***Breaker and Disconnect Refurbishment Project at Patrick TS –  
Notification of Approval of Connection Proposal - CAA ID Number: 2004-EX211***

# **Appendix<sup>1</sup> A: Description of Patrick St /Steelton TS Breaker/Disconnect Refurbishment Project & Single Line Diagram for the IMO Expedited System Impact Assessment Application (ESIAA)**

Figure 1 – Existing Single Line Diagram for Patrick St. TS and Steelton TS

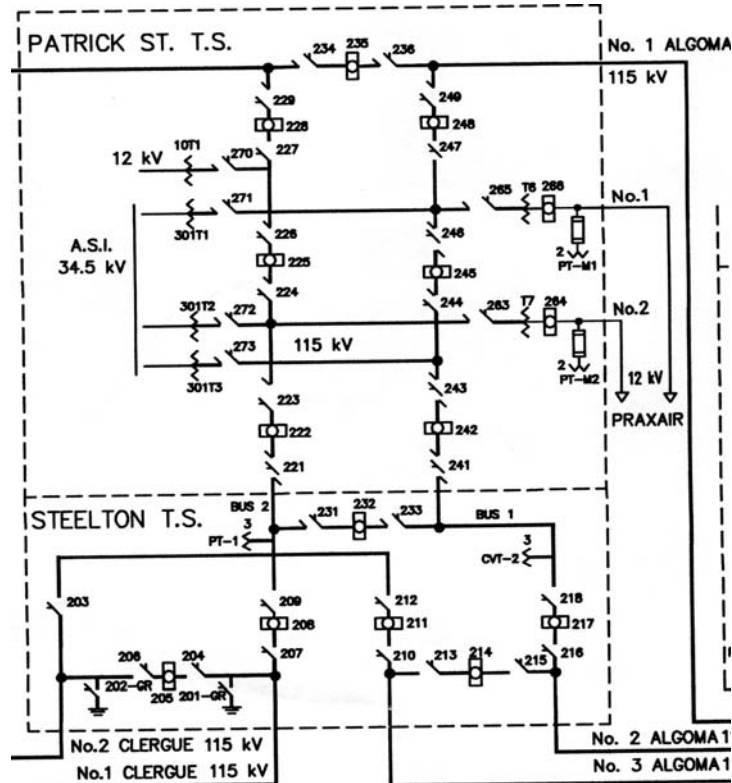
We have reviewed your proposal and concluded that the proposed upgrade does not have a material impact on the IESO-controlled grid. Based on the information you provided, the project falls under the category of “like-for-like” replacements and a formal Connection Assessment Study is not warranted, because:

- The new switchgear with the operating characteristics shown in Appendix B meet the Market Rules requirements and will have the same operating parameters and interrupting characteristics as the current breakers and switches; and
- Data monitoring for the new switchgear equipment will be supplied from the existing RTU, which will allow GLP to meet the requirements in Appendix 4.16 of the market rules.

The IESO is therefore pleased to grant **conditional approval** for the installation of the new equipment. Any material changes to your proposal may require a re-assessment by the IESO in accordance with Market Manual 2.10, and may nullify your conditional approval.
